Technical Service Information Bulletin

TRUNK WILL NOT CLOSE

'06 GS 300 & GS 430

BODY
B0001-06

**Parts
Identification
Method**

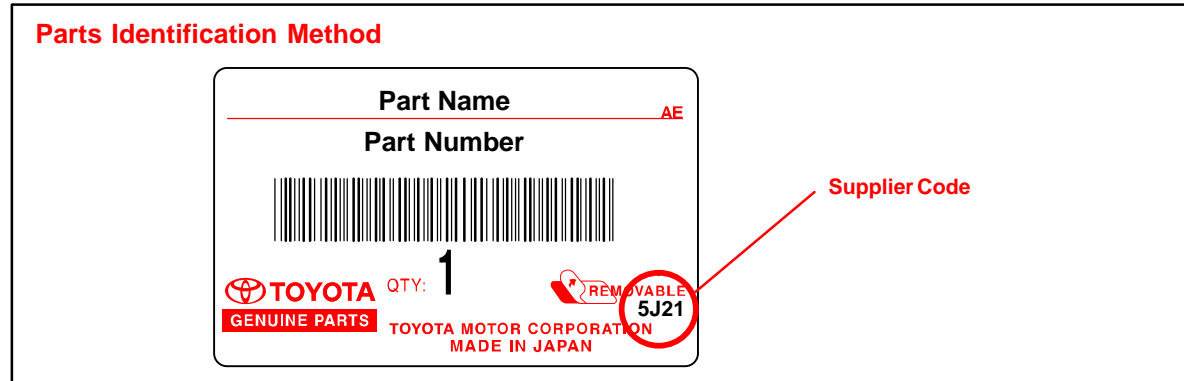
The supplier code on the part label should be “5J21” or higher.
